REMARKS

Claim 1 is directed to a device for inserting escape characters into a multi-byte wide data stream. The device includes a gap insertion component configured to receive blocks of data of the multi-byte wide data stream, where the gap insertion component

**Amendments to the Drawings:**

Fig. 5

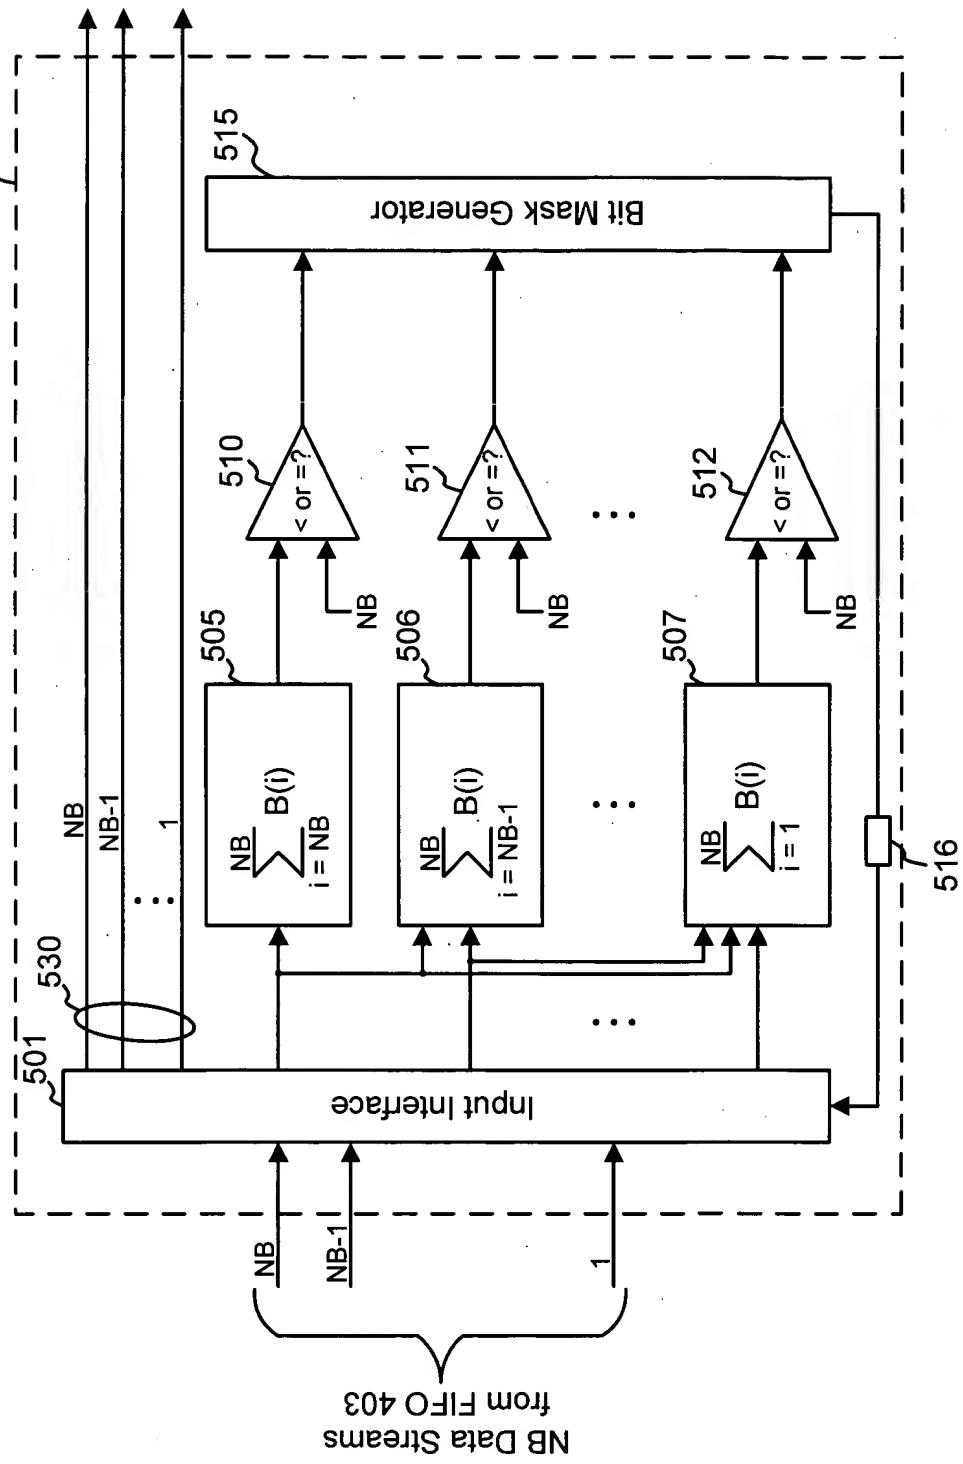
By this Amendment, Applicants have amended Fig. 5 to conform label “402” to label “404.” The specification correctly references label 404.

The attached sheet of drawings includes changes to Fig. 5. This sheet replaces the original sheet. In Fig. 5, label "402" had been changed to label "404" to correct a typographical error and to be consistent with the specification.
